Access Compliance Report

Public Rights-of-Way (Curb Ramps)

Intersection ID: 2853	Main Street: CARDINAL_POINT_RD	Cross Street: BENFIELD_RD	Location: NW
ADA ID: 4D794DD59B62	Ramp Type: Directional1	Initial Pass/Fail: Pass	Overall Compliance: No
Severity Score: 0			
Codes/Mitigation Info/Possible Solution		Field Measurements/Component Compliance

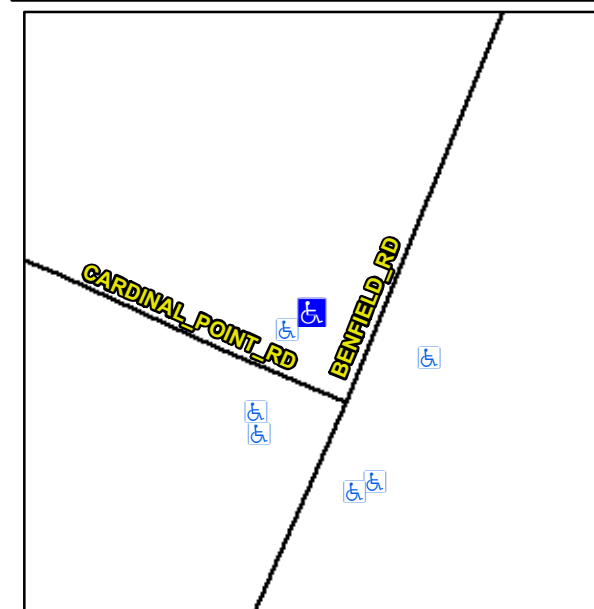
R304.5.3, R304.5.2

Compliance	Description	Data	Compliance	Description	Data
N/A	Ramp Length (in)	74.0	No	Grade Break?	No
Yes	Ramp Width (in)	71.0	N/A	Grade Break Slope (%)	6.5
Yes	Ramp Slope (%)	6.5	N/A	Grade Break XSlope (%)	3.7
Yes	Ramp XSlope (%)	1.7			
Yes	Flare Type LT	N/A	Yes	Flare Type RT	N/A
N/A	Flare Slope LT (%)	N/A	N/A	Flare Slope RT (%)	N/A
N/A	Flare Traversable LT?	No	N/A	Flare Traversable RT?	No
Yes	Landing Length (in)	73.0	Yes	DWS Provided?	Yes
Yes	Landing Width (in)	71.0	Yes	DWS Contrast?	Yes
Yes	Landing Slope (%)	1.1	Yes	DWS Length (in)	24.0
No	Landing X Slope (%)	2.2	Yes	DWS Full Width?	Yes
N/A	Landing Curb? (Y/N)	N/A	Yes	DWS Offset LT (in)	2.0
N/A	Shared Landing?	No	Yes	DWS Offset RT (in)	12.5
Yes	Gutter Ponding?	No	Yes	Gutter Slope (%)	0.1
Yes	Gutter Lip Ht (in)	0.0	Yes	Gutter X Slope (%)	0.6
N/A	Painted X Walk1?	No		Road Slope (%)	4.2
	X Walk 1 Direction	To E		Road X Slope (%)	0.1
	X Walk 1 Width (in)	N/A		Clear Space?	Yes

Remove & Replace Entire Ramp.
